## RESOLUTION NO. CR-16-20

### A RESOLUTION TO APPROVE THE DEVELOPMENT PLAN FOR FARMSTEAD SUB AREA H LOCATED AT 62 JACKSON PIKE

## ITEM 5: 202003040010 – Farmstead Subarea H (Development Plan)

**Subject: Farmstead Sub-Area H - Final Development Plan**

DRAWING NO: **C700**  
 SHEET 7 OF 11

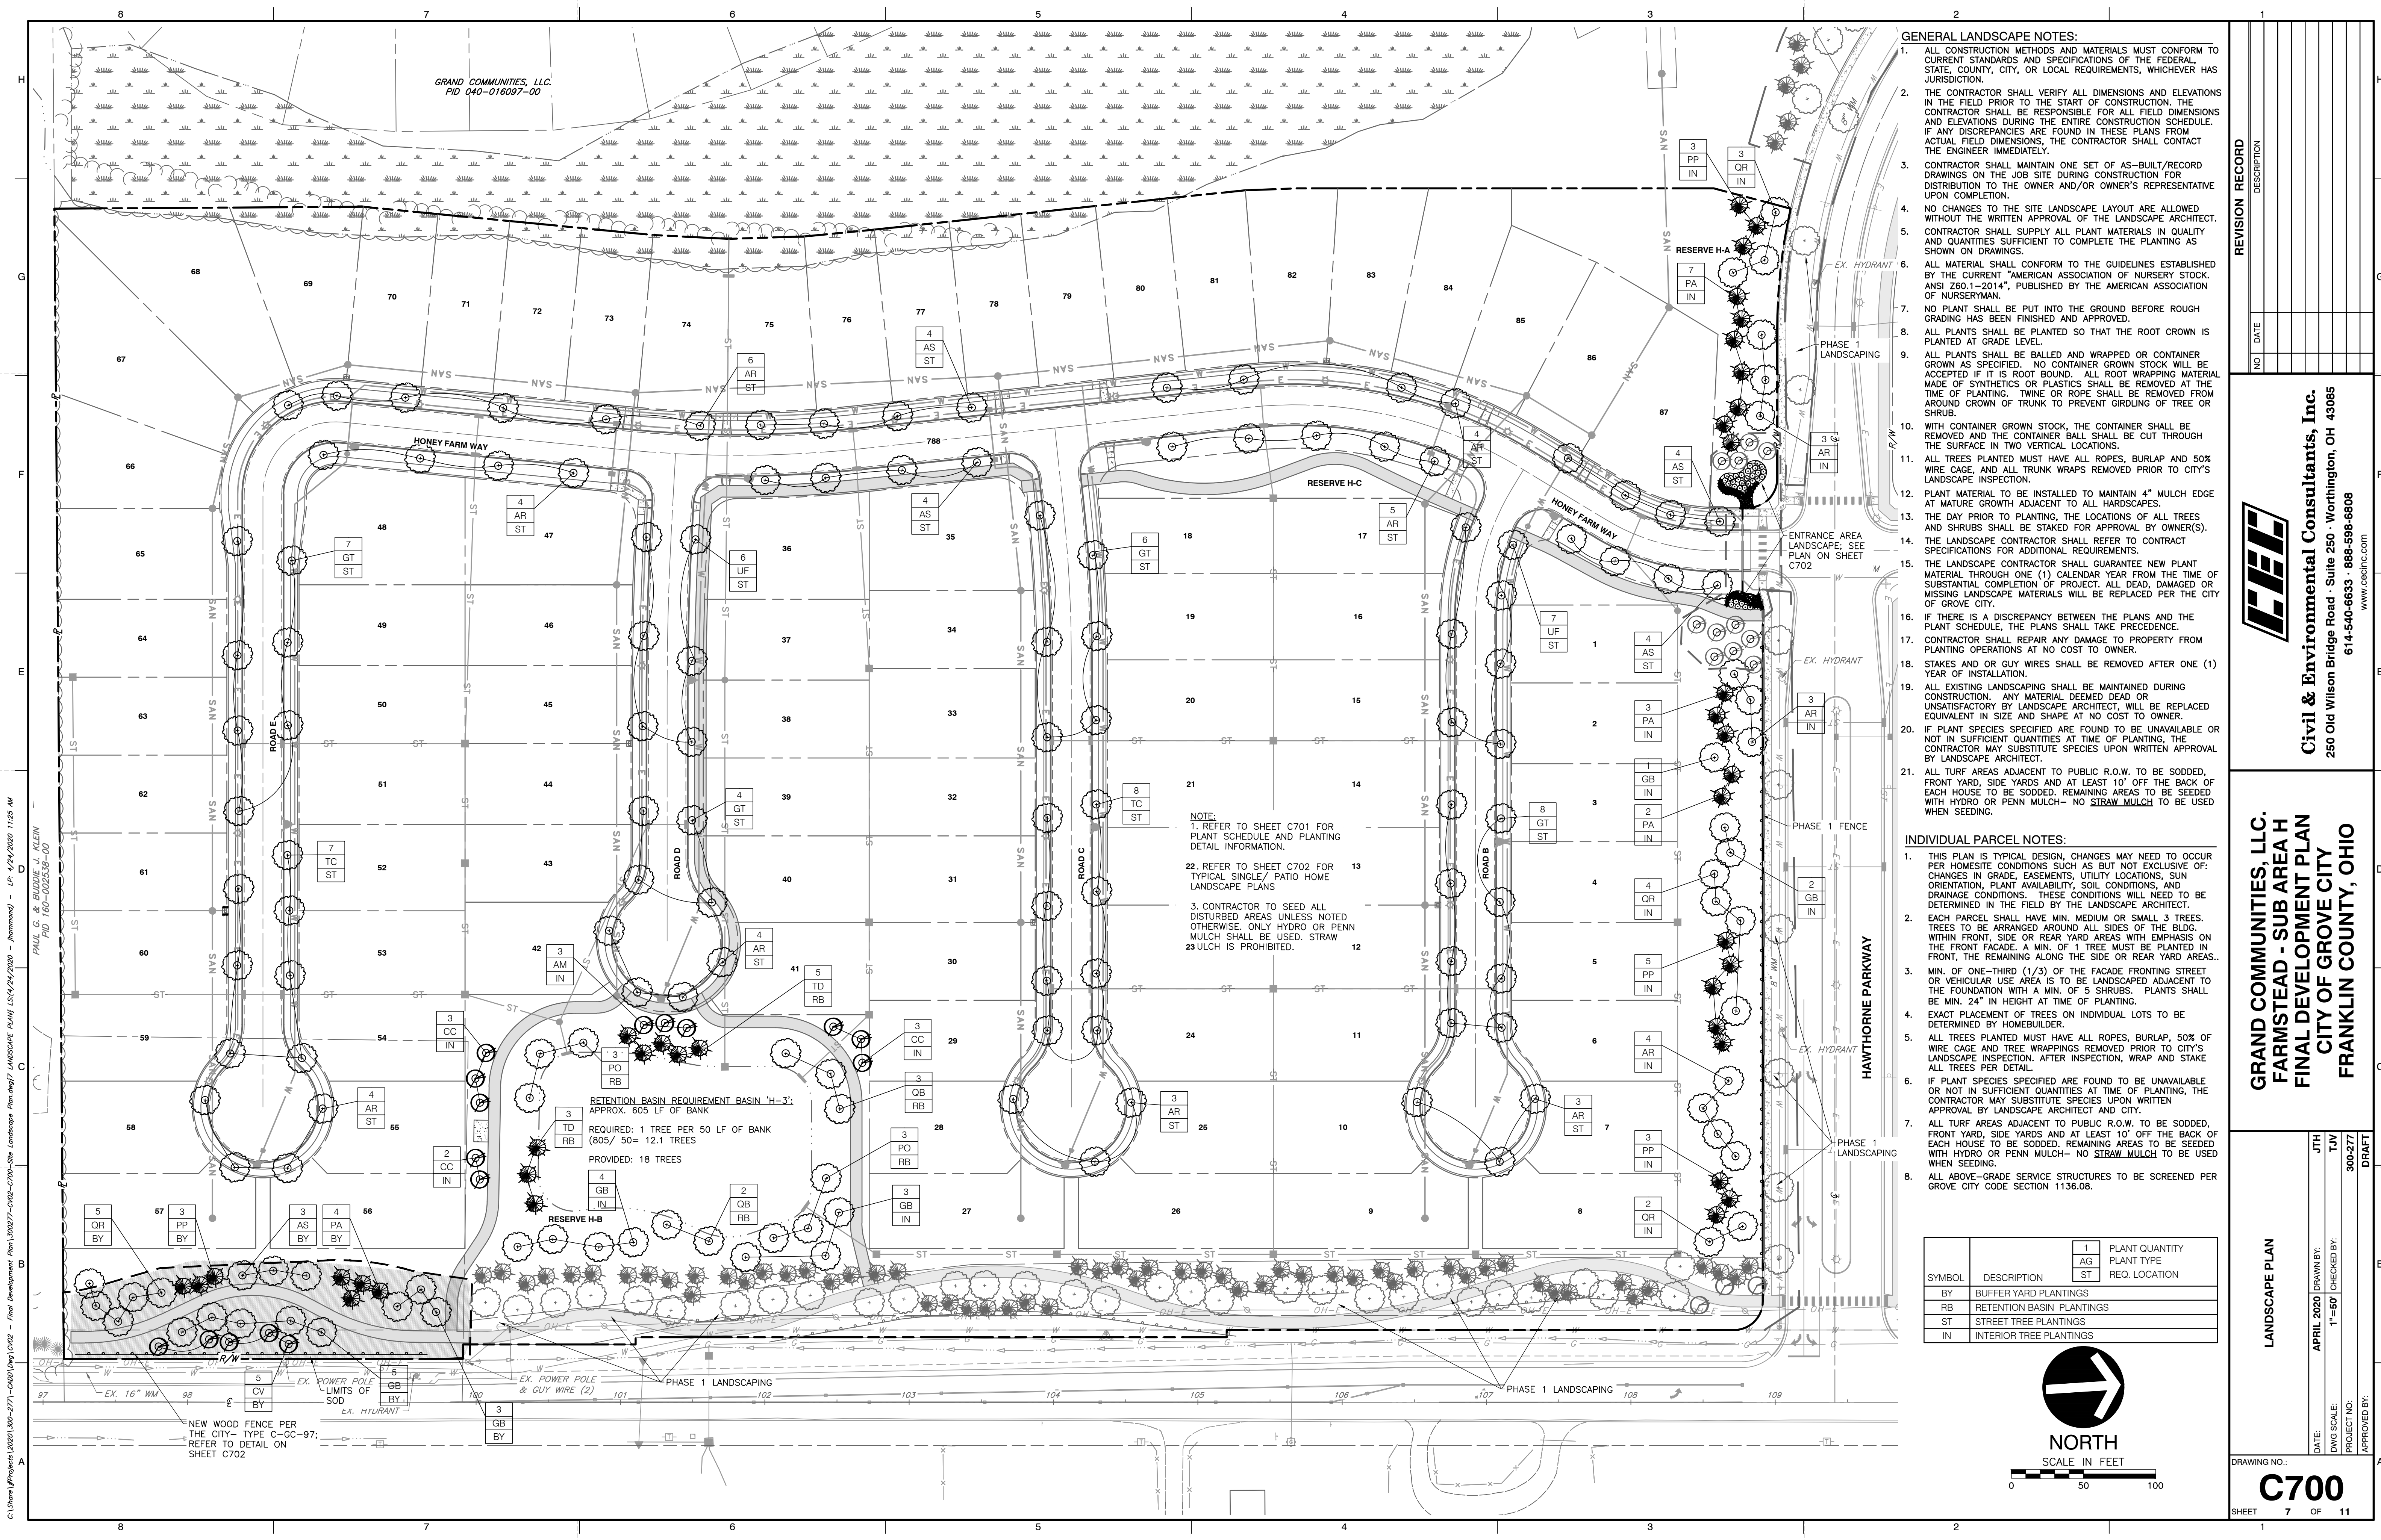
5. Please correct Comment #21 of the General Landscape Notes on page C700 to state the exact same wording as Individual Parcel note #7, which is correct as written.

**A typical detail for the CBU has been added on sheet C701, and is consistent with the Farmstead Development.**
9. An updated version of Note #1 of Individual Parcel Note still requires correction. Pages C700 and C702 are not consistent, as note #1 for The Individual Parcel notes; page C702 lists as #2.

**All general notes have been updated and are now similar on both pages C700 & C702.**
10. All lots appear to be large enough to have 3 trees planted on them (street trees do not go towards this count, they are in addition to the 3 required per lot). Please state the lots you feel are not large enough for 3 trees and then show on landscape plan where these trees would be planted in the open area by labeling them with the associated Lot #.
